Determination 2024/050

Regarding compliance with the Building Code and the issue of a code compliance certificate for building work associated with a new dwelling

4 Valley Heights Lane, Auckland

Figure 2: Upper level floor plan showing location of the deck

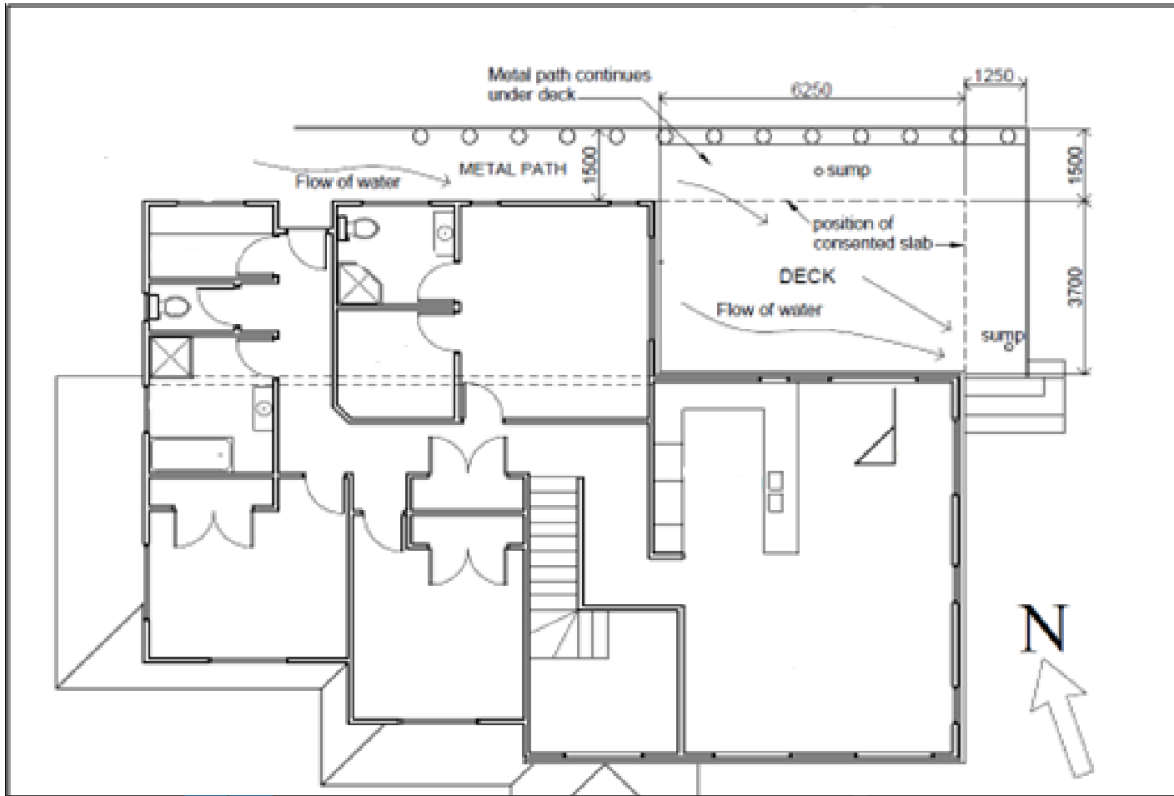
- 2.4. During construction a 6.25m x 3.70m timber deck was built in place of the patio (see Figure 2 'position of consented slab'). The timber deck was later extended over the metal path, and now measures approximately 7.50m x 5.20m. Timber stairs off the southeast of the deck follow the contour of the ground.

- 2.7. The surface water drainage system in the vicinity of the deck consists of downpipes, pipework, drains and a sump (Figure 2).⁴ The surface water appears to discharge to the ground under and around the deck area and travels toward the east of the site and down that side of the building.

- 3.4. Removal of surface water under the deck was 'never catered for.' No attempt was made when the dwelling was constructed to have surface water which collects under the deck fall away from the dwelling and be directed to a drainage outlet. Surface water should be draining to an approved outlet.

- 3.6. The drainage should have been redesigned and altered to make it 'fit for purpose' to drain water from beneath the deck, and the sump in the path should have been moved under the deck to collect surface water.

4.45. I am of the view that the permeable ground below the deck in this case is an appropriate outfall in accordance with clauses E1.3.1 and E1.3.2 because surface water is not entering the building nor causing a nuisance or hazard to other property.

Figure 3: Lower level showing block foundation walls

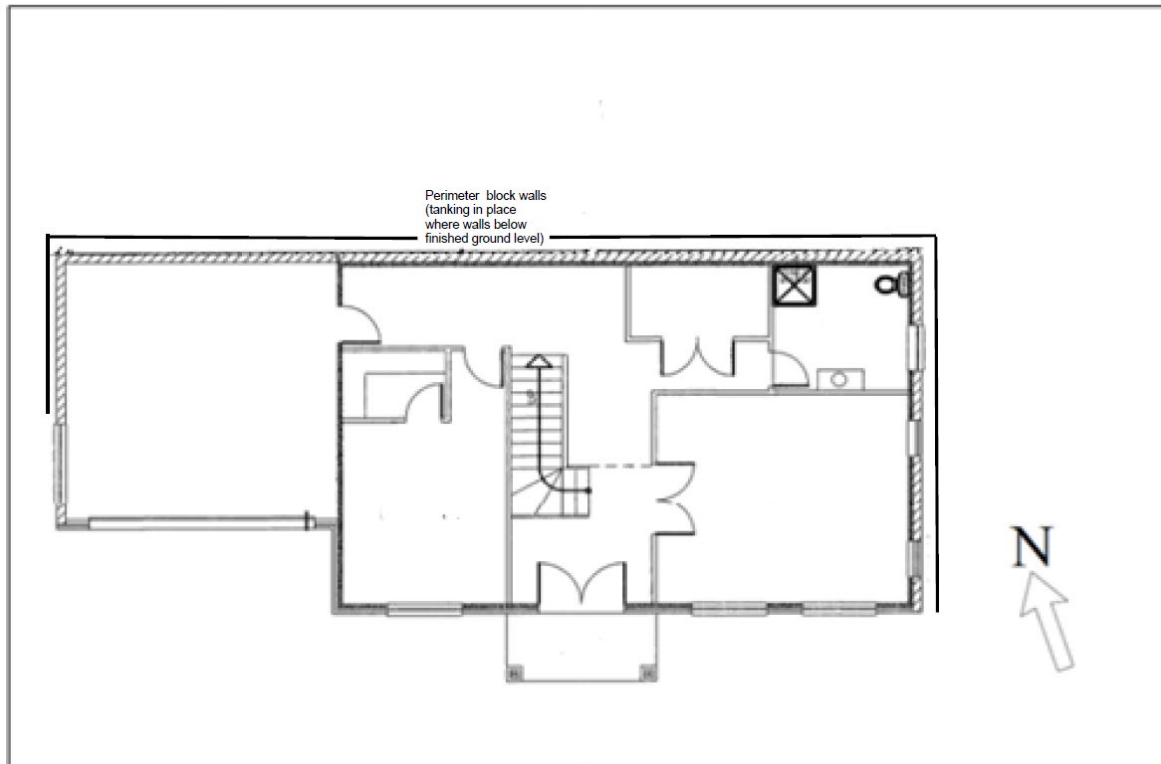
- 2.2. Approximately one quarter of the upper level is founded on a slab foundation which is supported by a perimeter footing and a concrete block retaining wall (“the block wall”) which can be seen in Figures 2 and 3. The block walls have a waterproofing tanking applied below ground level and sub-soil drainage at the base of the wall. The remaining upper-level floor structure consists of a timber joist and steel beam mid-floor generally following the outline of the lower level.
- 2.3. The approved building consent drawings specified a “deck” on the upper-level floor plan to the northeast of the dwelling, accessed off the dining room. But the floor framing and foundation plan and cross section ‘A’ specified a 100mm thick concrete slab (“the patio”) supported by what appears to be a block foundation edge.

- 3.8. Tanking is missing from some of the perimeter walls. This area supports a habitable space and is susceptible to hydrostatic pressure and slab edge dampness which can cause dampness to the interior by capillary action up through the blocks and concrete floor.

- 4.59. In lieu of these indications of failure and on the basis these walls have at least some tanking membrane and sub-soil drainage, I consider these walls will continue to prevent the penetration or transmission of external moisture to the extent required by clauses E2.3.2 and E2.3.3 and for a period of no less than 50 years from the date of the code compliance certificate issue.
